CITY COUNCIL MEMORANDUM

FROM: The Office of the City Manager **DATE:** June 8, 2020
SUBJECT: SUP 2020-03, Ordinance No. 3654, Public hearing and consideration of a request from Dominique Van Ausdall for a revised special use permit for a brewpub at 7924 Maplewood Avenue, being 0.8 acres described as Lots 2R and 6, Block 23, Clear View Addition.
PRESENTER: Clayton Comstock, Planning Director

Building design

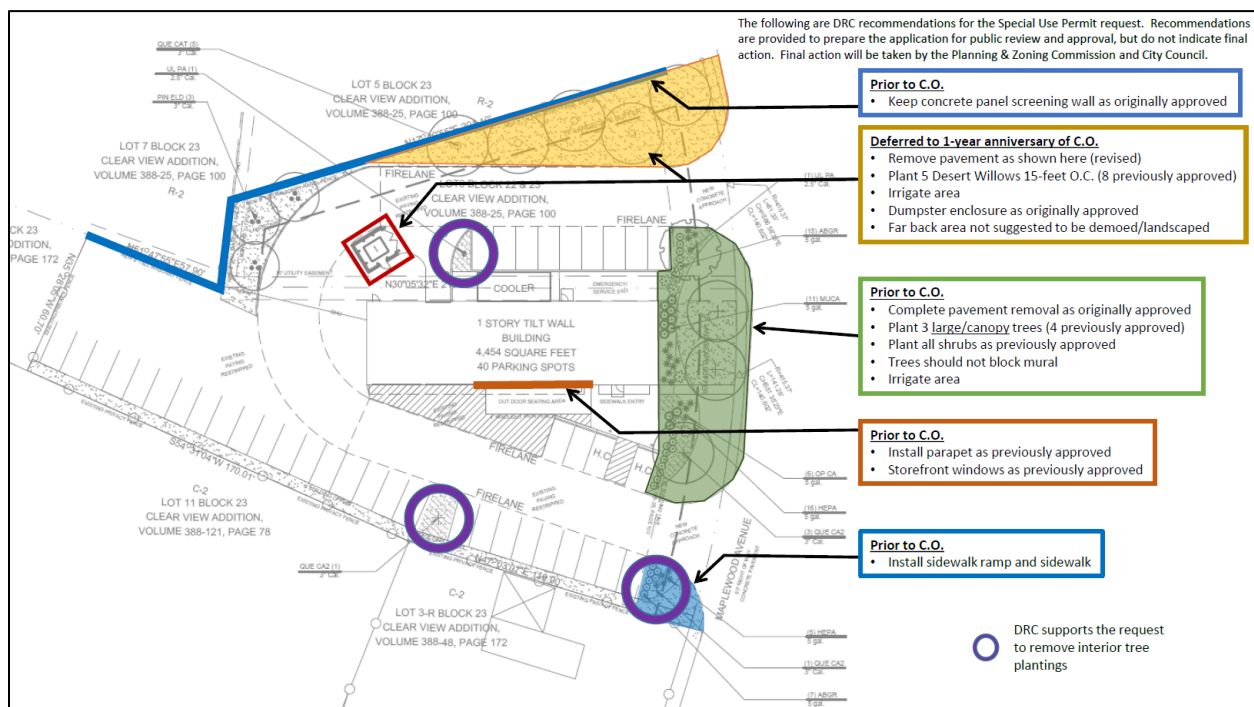
The original SUP approval included architectural design for the building exterior and removal of pavement in some areas of the property. The building design included a central parapet feature on the south elevation, which served as both a screening device for roof-mounted equipment and as an area for signage. The building design also included the replacement of two metal overhead doors with two glass overhead doors.

The applicant installed a screening device around the roof-mounted equipment and proposes to substitute this device for the central parapet feature. The applicant also is requesting to retain the existing metal overhead doors on the building. The exhibits below show the building design approved as part of the original SUP and the proposed building with screening device and existing overhead doors.

PLANNING AND ZONING COMMISSION: The Planning and Zoning Commission conducted a public hearing and considered this item at the May 21, 2020, meeting and voted 6-0 to recommend approval subject to a waiver of the parapet wall and glass bay door requirements, and with all other site improvements being completed by issuance or certificate of occupancy or deferred to one year after issuance as recommended by the Development Review Committee.
